GTR22: ERRONEOUS UBE-CALCULATION

EVE 81

Ispra, Italy

25.03.2024

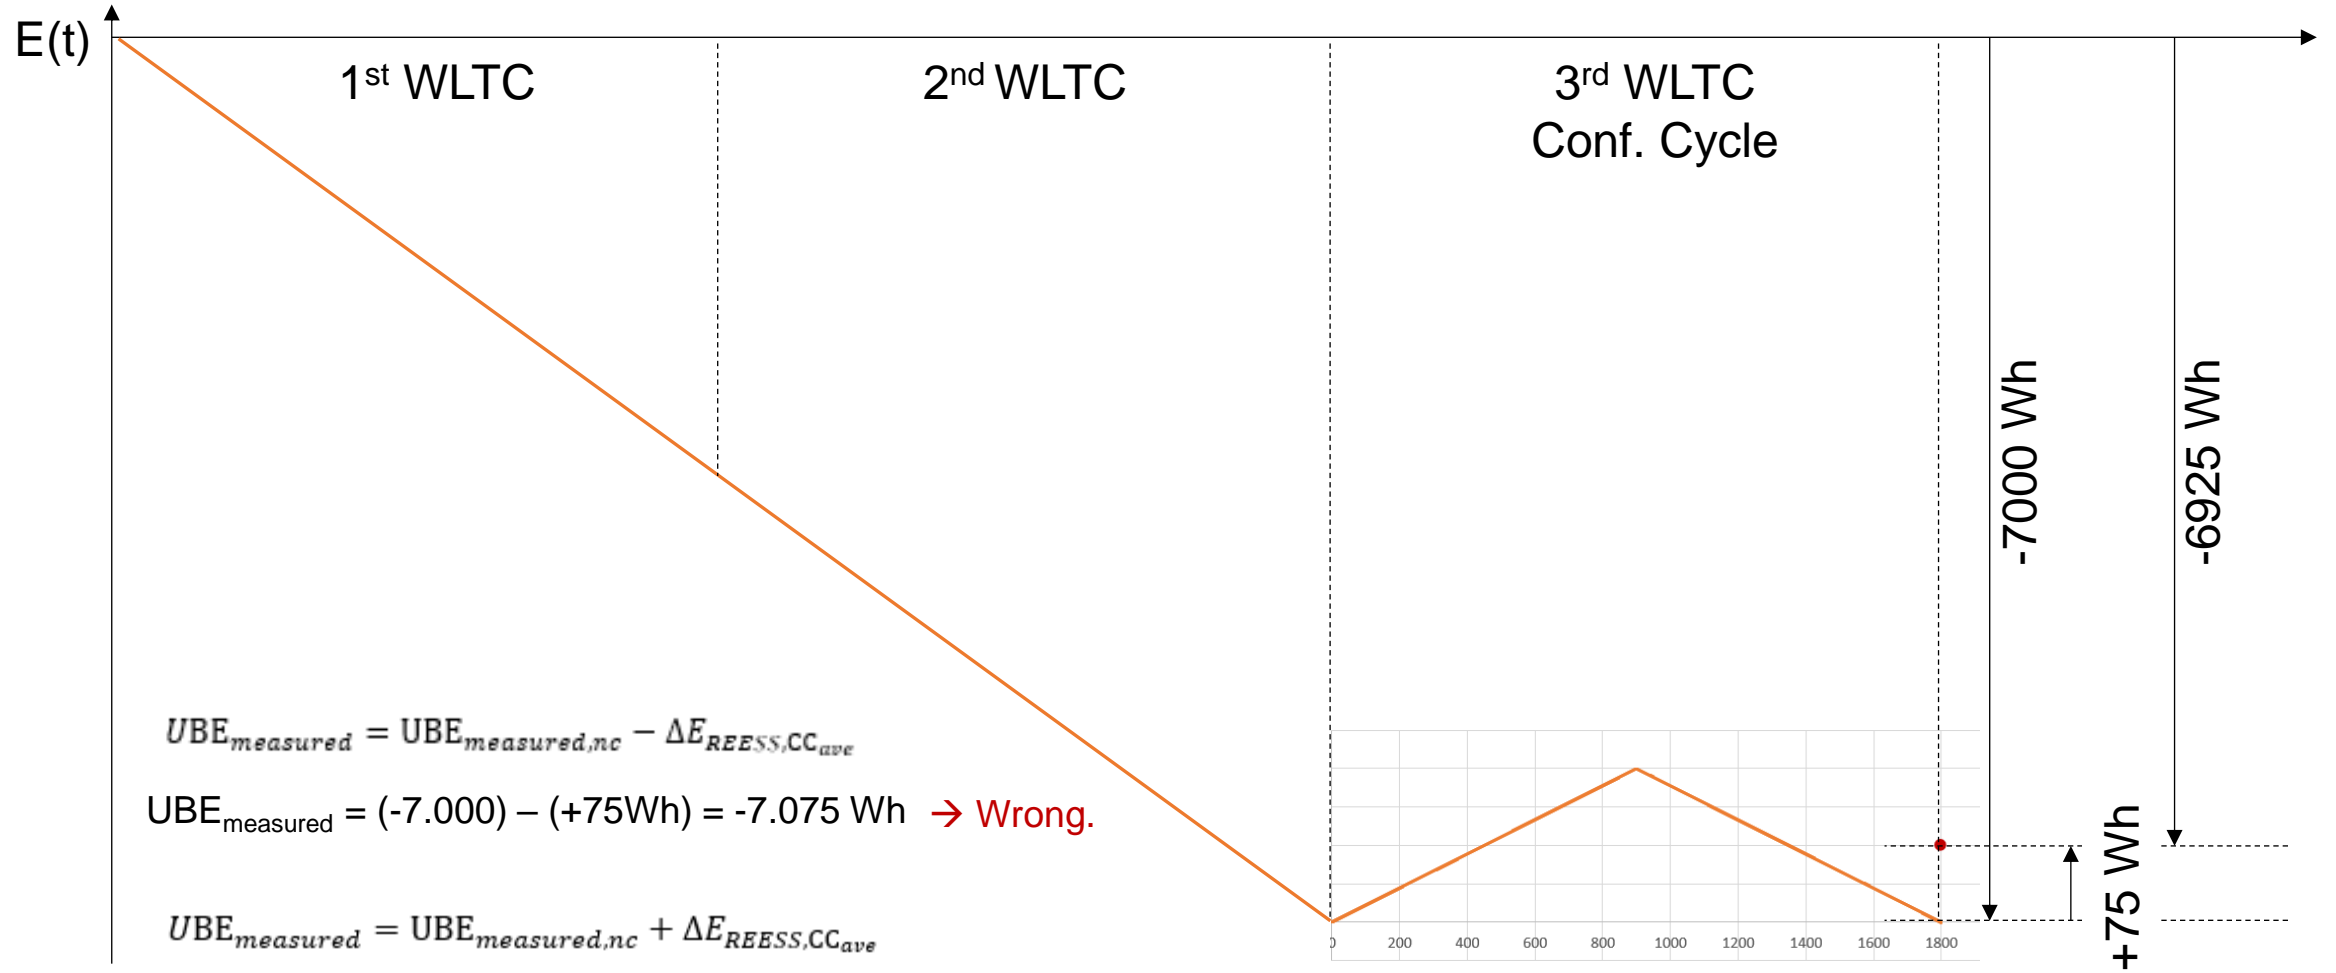
Current I(t) acc. To GTR 15/UN R 154 shall be negative if a REESS is discharged.
Acc. to equation it means that UBE is negative as well.

For the example below lets assume -7.000 Wh. Please find it on the right hand side represented by the blue dot.

Relative within CC it is +75 Wh but absolute about the whole CD-test it is assumed -7000 Wh.

With the assumption that the current I(t) is again negative when discharged applying the equation results in -75 Wh. See red dot. Blue dot represents the assumed absolute -7000 Wh over the whole CD-test incl. the CC.

ERRONEOUS UBE-CALCULATION

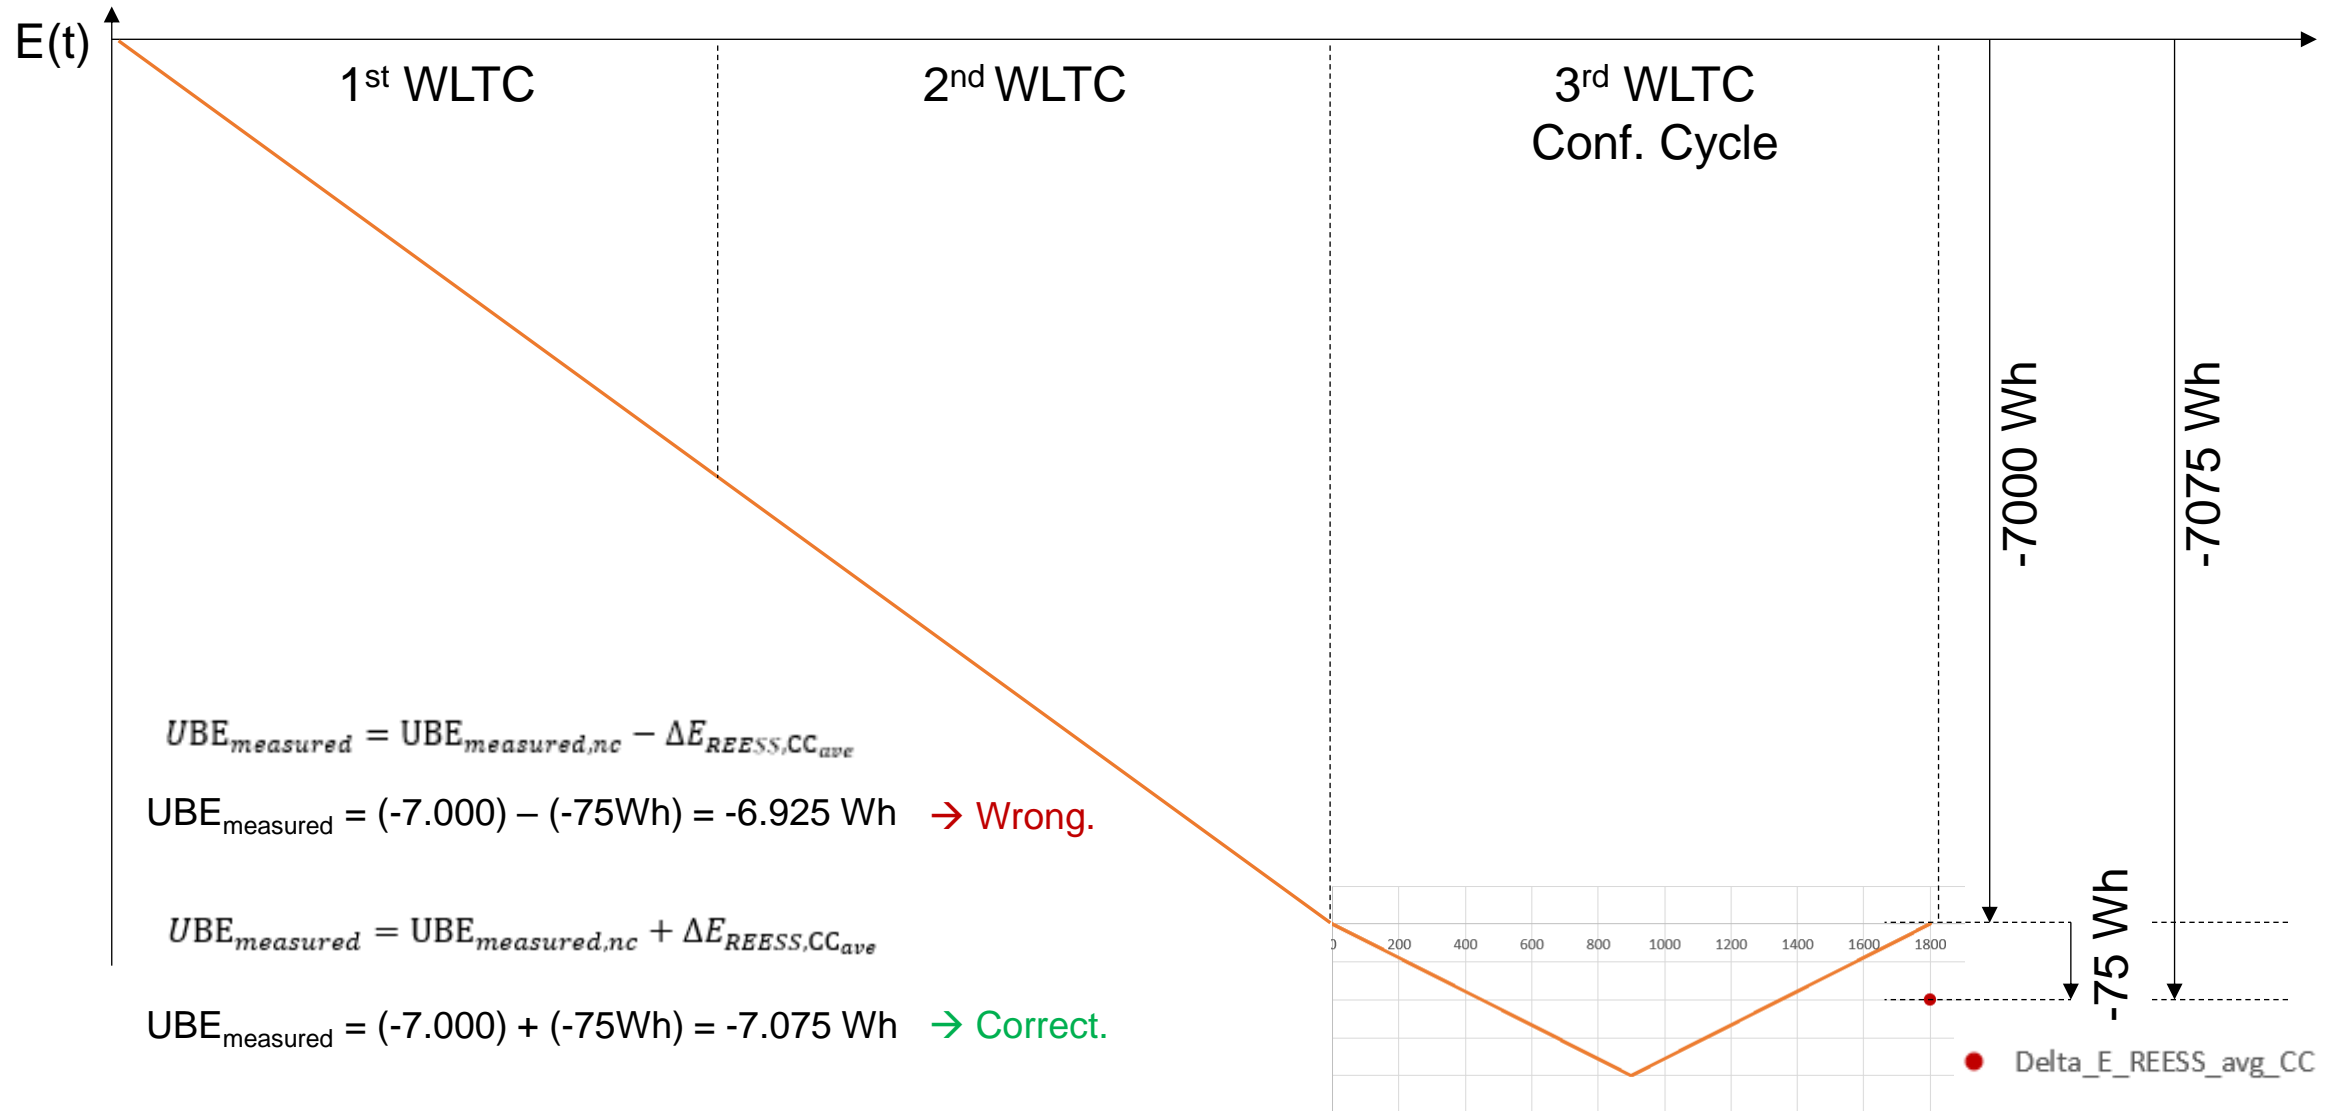
$$UBE_{measured} = UBE_{measured,nc} - \Delta E_{REESS,CC_{ave}}$$

$$UBE_{measured} = (-7.000) - (+75Wh) = -7.075 Wh \rightarrow \text{Wrong.}$$

$$UBE_{measured} = UBE_{measured,nc} + \Delta E_{REESS,CC_{ave}}$$

$$UBE_{measured} = (-7.000) + (+75Wh) = -6.925 Wh \rightarrow \text{Correct.}$$
